Model Error Resolution Document

1. Document Number:	MDL-NBS-HS-000010	2. Revision/Addendum:	03/01	3. ERD:	01
---------------------	-------------------	-----------------------	-------	---------	----

4. Title:	Site-Scale Saturated Zone Transport
-----------	-------------------------------------

Figure A-39[b]. Selenium Sorption Coefficients on Zeolitic Tuff versus Calculated Final Selenium Concentration in Solution

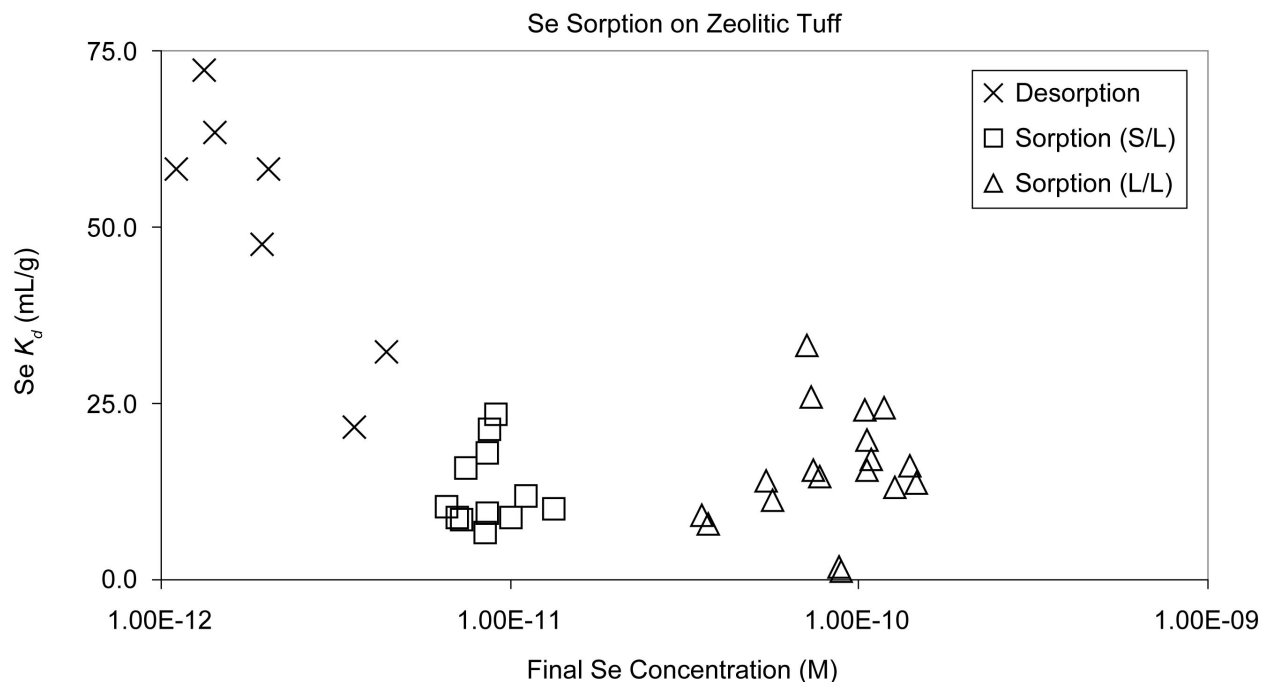
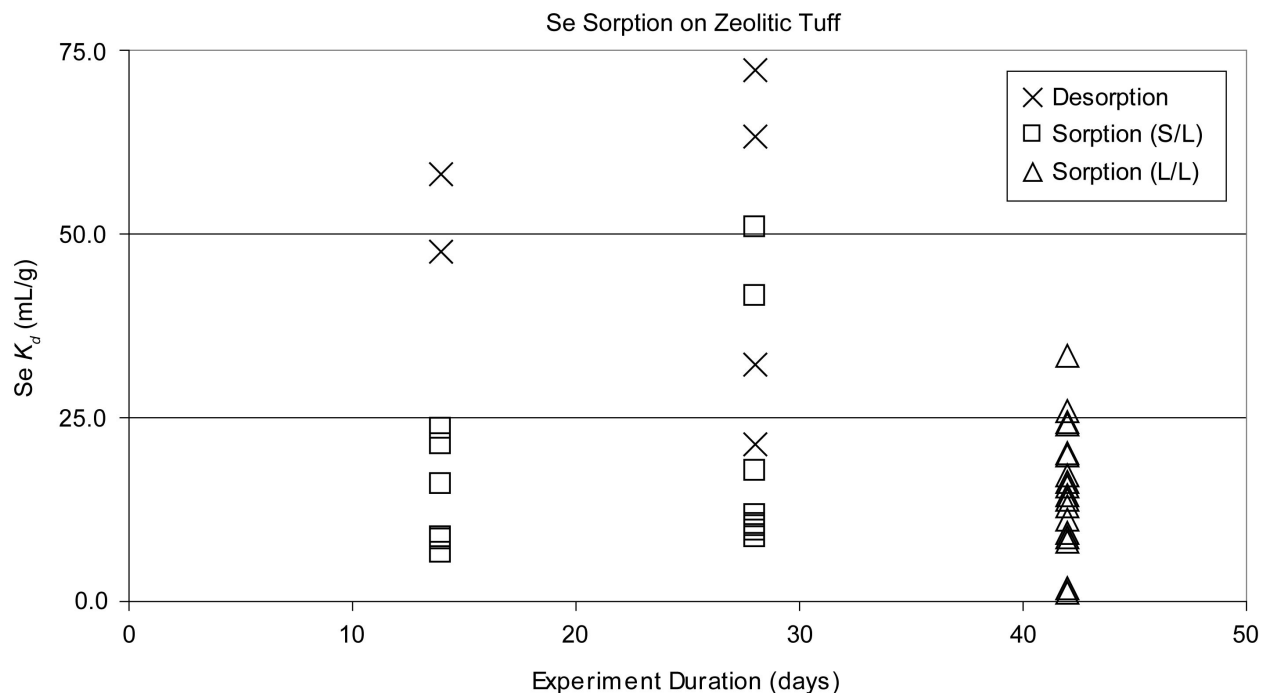
DTN: LA0702AM831341.001 [DIRS 179306] was superseded by DTN: LA0802AM831341.002 [DIRS 185081] to revise two data values attributed to transcription error and to revise the rock type classification of the samples G1-2233, G1-2289, G1-3116, G2-0547, GU3-1531, and GU3-433. The entries corresponding to DTN: LA0702AM831341.001 [DIRS 179306] in Table 4-1[a] and Section 9 of MDL-NBS-HS-000010 REV 03 AD 01 were changed. Figures A-36, A-37, A-39, and A-40 in MDL-NBS-HS-000010 REV 03 AD 01 were replaced.

Figures A-39 and A-40, and the first paragraph of Section A7.7.2 are replaced by the following:

Although data from the superseding DTN, plotted in Figure A-39[b], are different from those plotted in Figure A-39, the text explaining Figure A-39 remains valid for Figure A-39[b]. The K_d distribution remains unchanged.
